**CONSTRUCTION BULLETIN
No. 002**

**Institution: California Institution for Men (CIM)
Project Name: Replace Roofs Phase 1
Construction Bulletin Number: 002
Date of Issuance: February 6, 2026**

Description: This Bulletin makes modifications and corrections to the Project Manual and Drawings as described below.

DATE: 11/03/2025
SHEET NUMBER
A1.5
09 OF 80 SHEETS V1

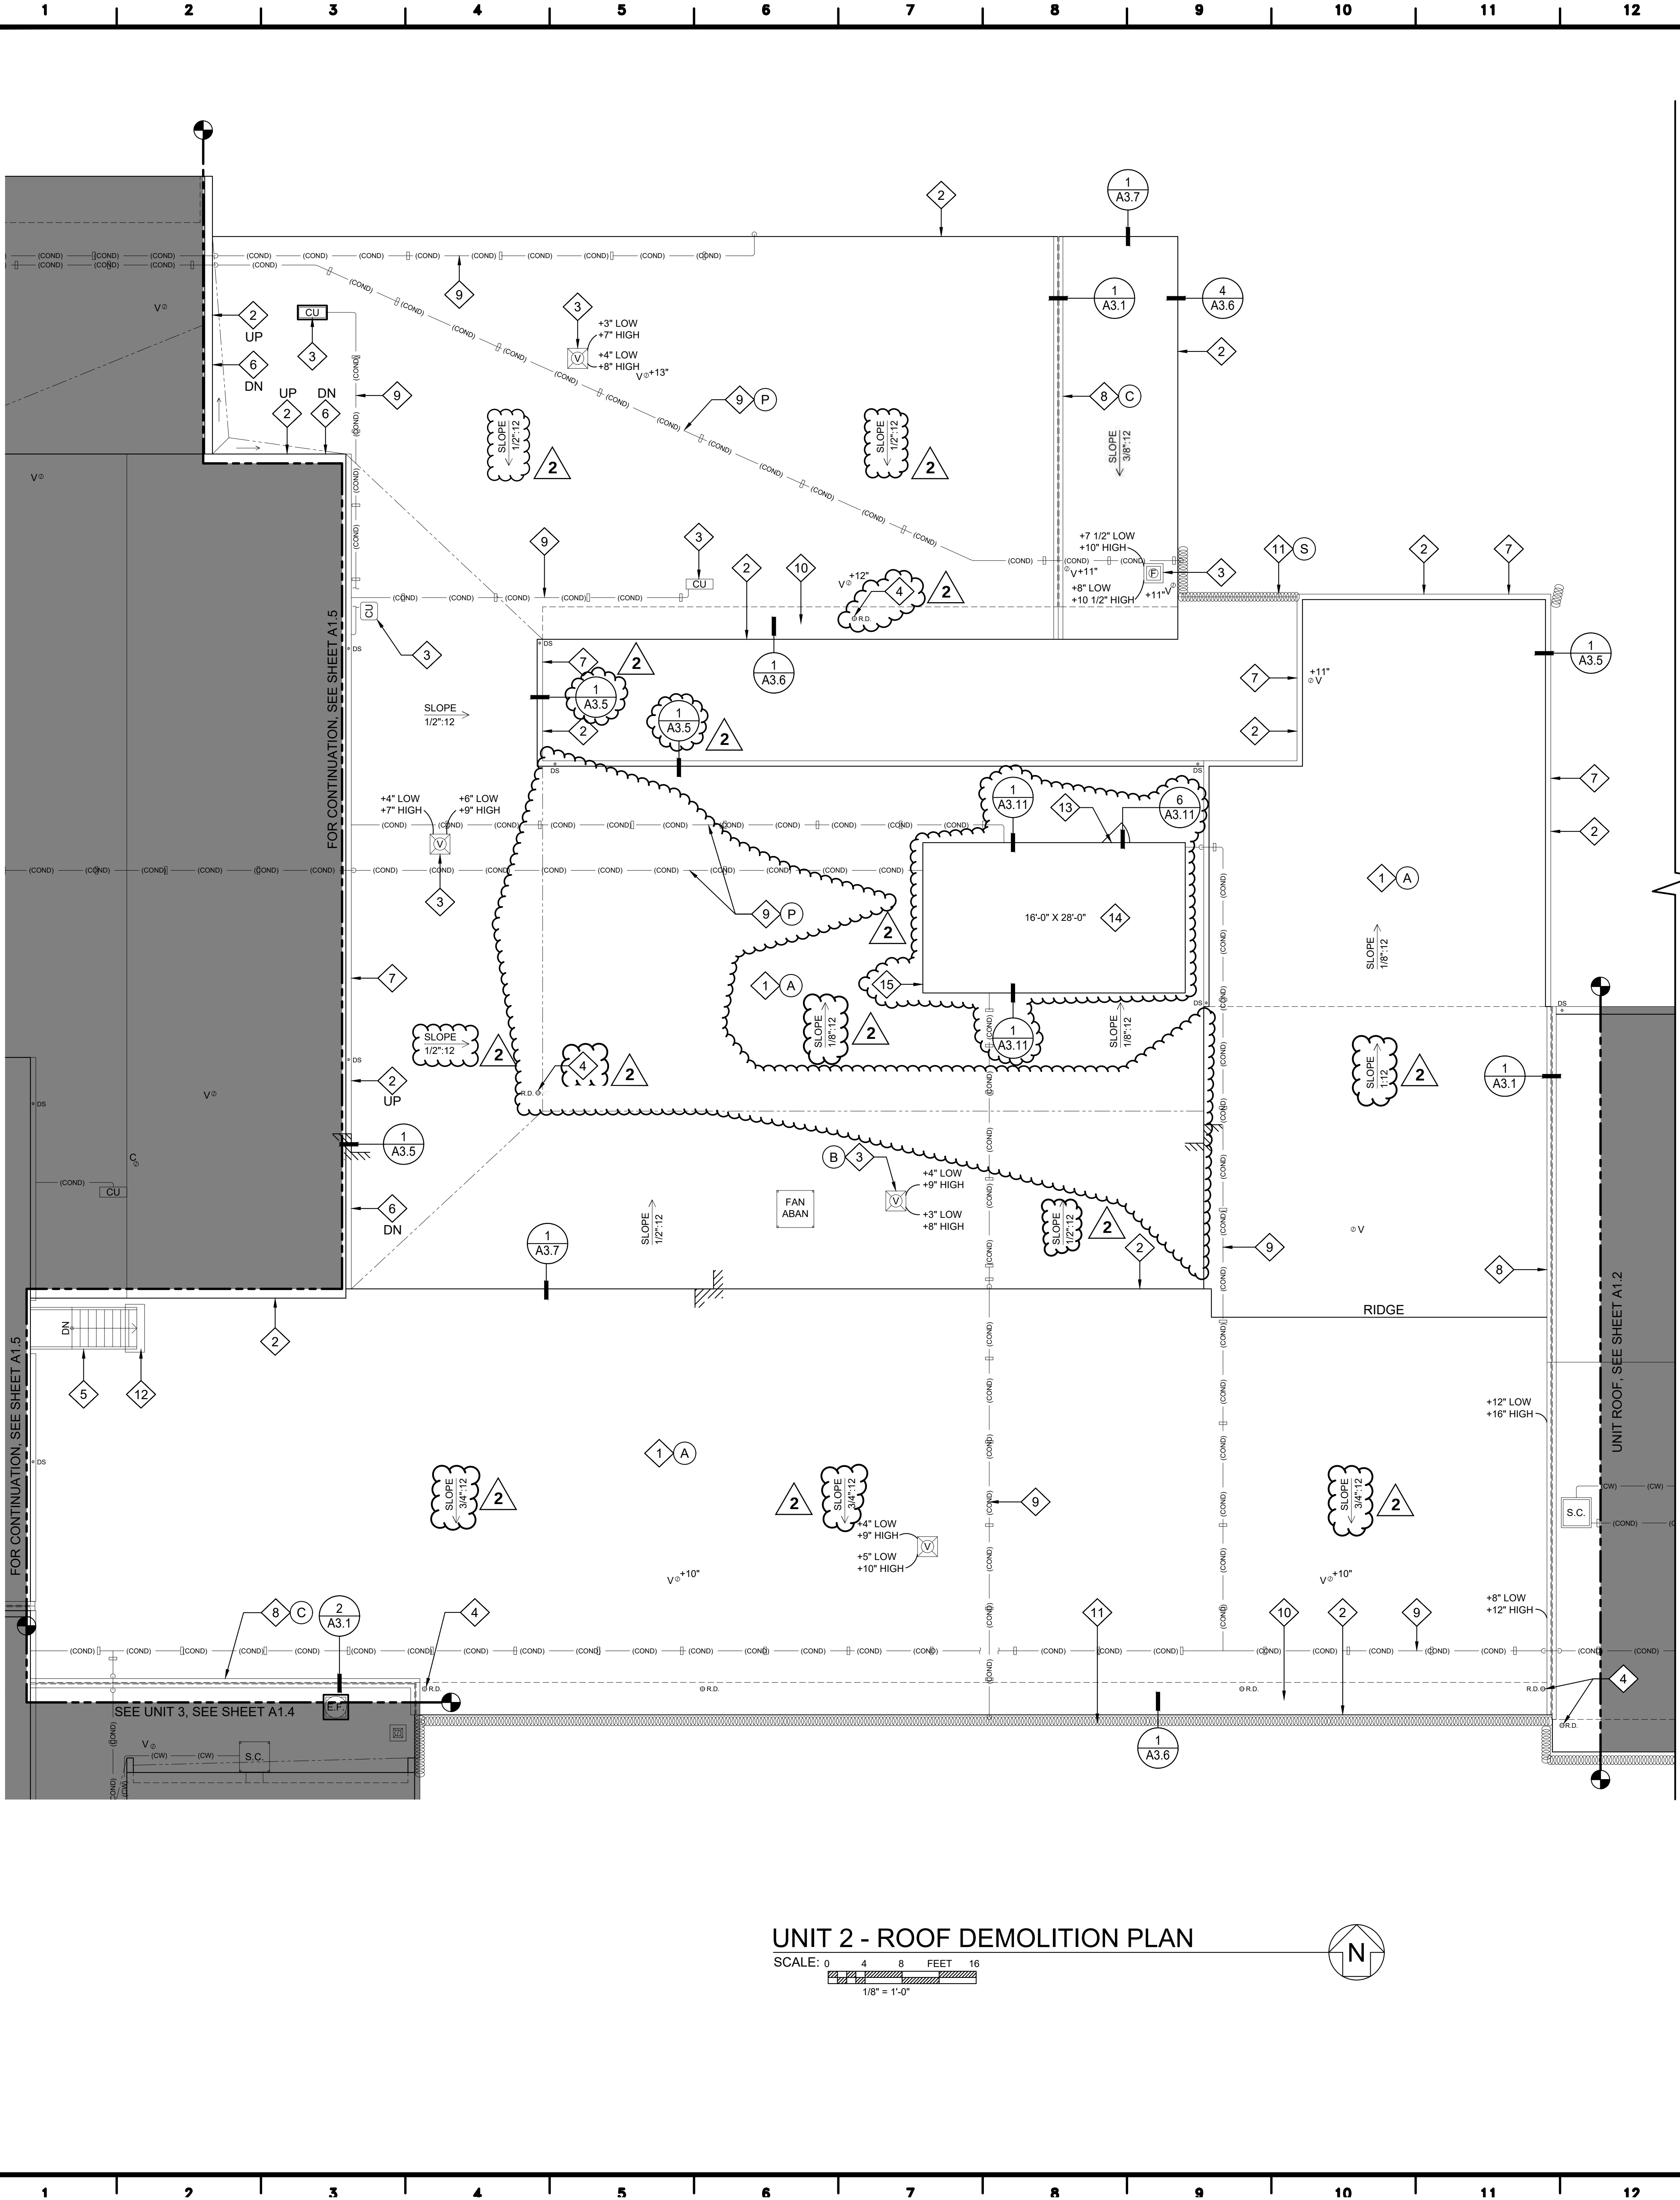
5. Sheet **A1.5 – UNIT 2 –ROOF DEMOLITION PLAN**
 - a. **Modify** DEMOLITION KEYNOTE 12 text from REMOVE THROUGH WALL SCUPPER AND FINISHING to REMOVE THROUGH WALL SCUPPER AND FLASHING DETAIL SEE 6/A3.6

- b. **Modify** DEMOLITION KEYNOTE 16 text from RELOCATE DOOR & FRAME to REMOVE L 2-1/2 X 2-1/2 X 1/4 HEADER & L 5 X 3 X 1/4. MOVE BOTH UP TO ACCOMMODATE CURB EXTENSION. REINSTALL (E) DOOR AND FRAME. SEE DETAIL 6/A3.11

- c. **Add** DEMOLITION KEYNOTES 17
 - d. **Add** DEMOLITION KEYNOTES 18
 - e. **Modify** PROTECT IN PLACE KEY KEYNOTE M from PRE-FABRICATED METAL BUILDING WITH (E) ROOFING TO REMAIN to NOT USED

- f. **Rearrange** PROTECT IN PLACE KEYNOTES N, P, and Q for clarity
 - g. **Move** SLOPE 1/2":12 note for clarity
 - h. **Remove** DETAIL 7/A3.7
 - i. **Add** DETAIL 7/A3.7

- j. **Add** DETAIL 7/A3.7
 - k. **Modify** roof slope from 3/8:12 to 1/8:12
 - l. **Modify** roof slope from 1/4:12 to 1/2:12
 - m. **Modify** roof slope from 3/4:12 to 1/2:12

- n. **Modify** roof slope from 7/8:12 to 1:12
 - o. **Modify** roof slope from 5/8:12 to 1/2:12
 - p. **Move** roof slope 3/8:12
 - q. **Add** roof slope text 1:12

- r. **Remove** roof slope text 3/4:12
 - s. **Remove** incorrect linework and slopes at roof around Mechanical Penthouse
 - t. **Add** Mechanical Penthouse Roof to scope of work

- 1) **Add** DEMOLITION KEYNOTE tag17
 - 2) **Add** DEMOLITION KEYNOTE tag18
 - 3) **Add** DETAIL1/A3.11
 - 4) **Add** DETAIL16/A3.11
 - 5) **Add** dimensions

DATE: 11/03/2025
SHEET NUMBER
A2.2
12 OF 80 SHEETS V1

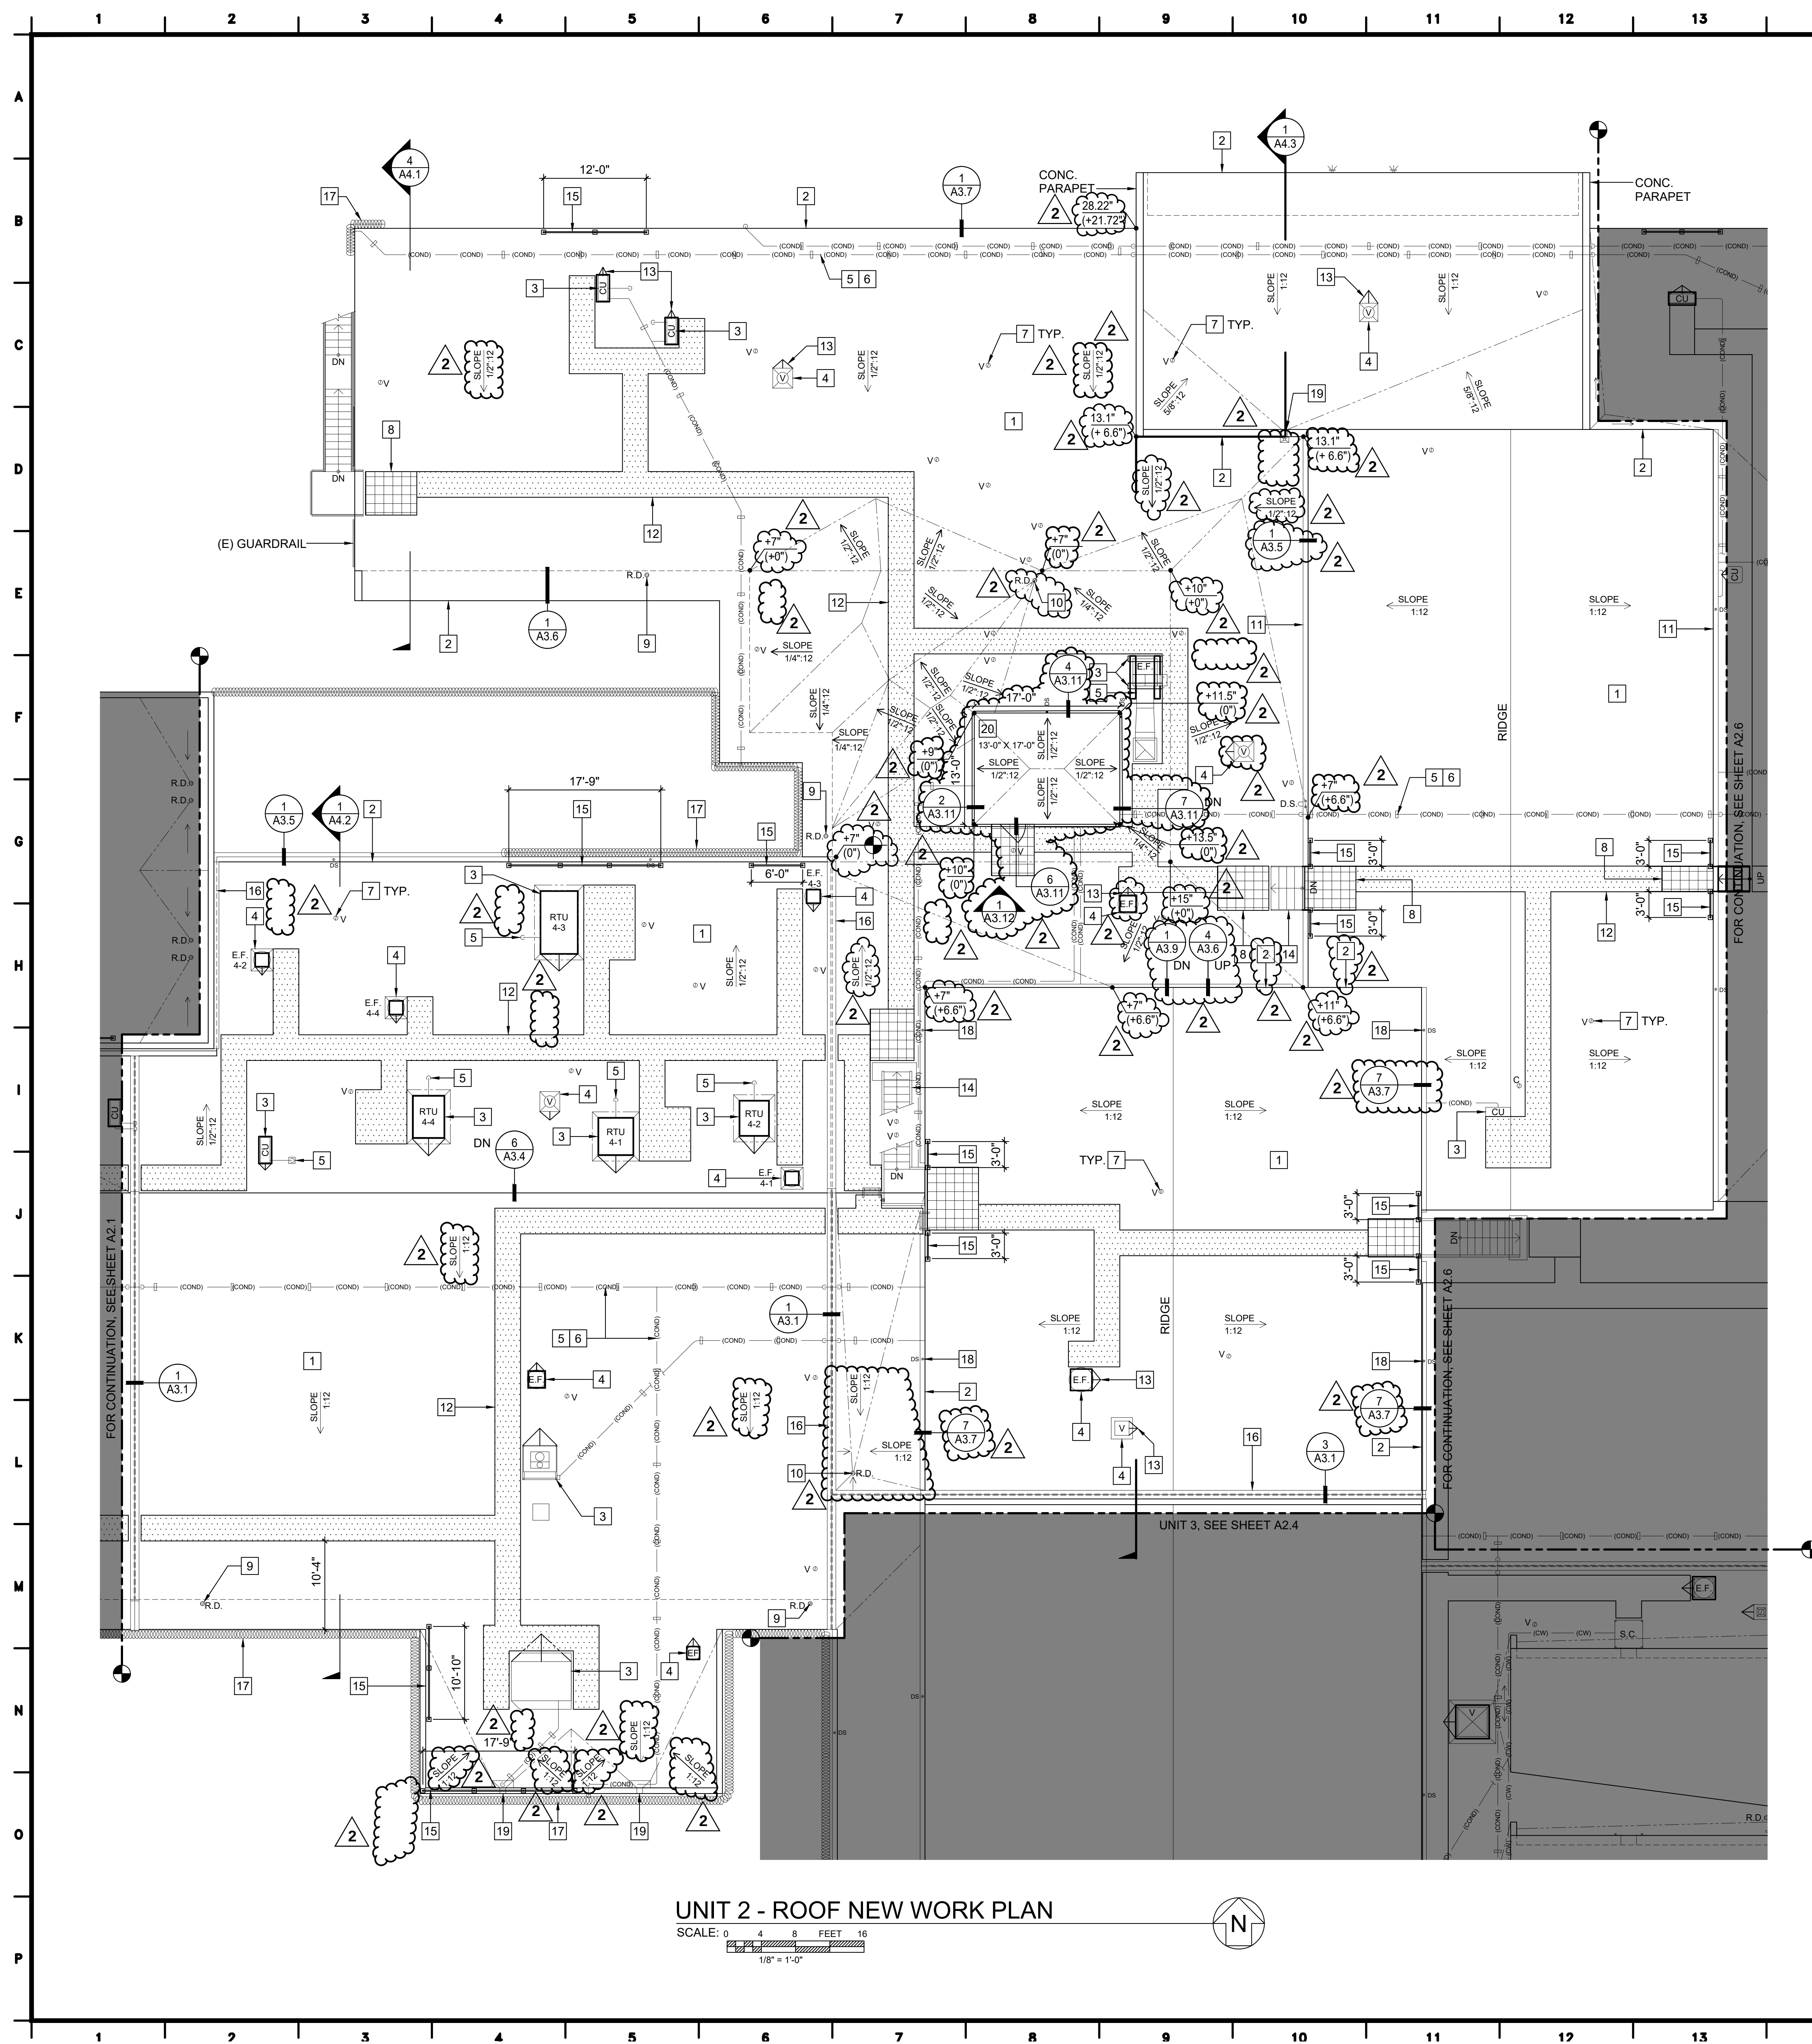
- a. **Change** NEW WORK KEYNOTE tag from 9 to 8
 - b. **Move** NEW WORK KEYNOTE 14 for clarity
4. Sheet **A2.2 – CYPRESS & PALM –ROOF NEW WORK PLAN**
- a. **Change** NEW WORK KEYNOTE tag from 15 to 12
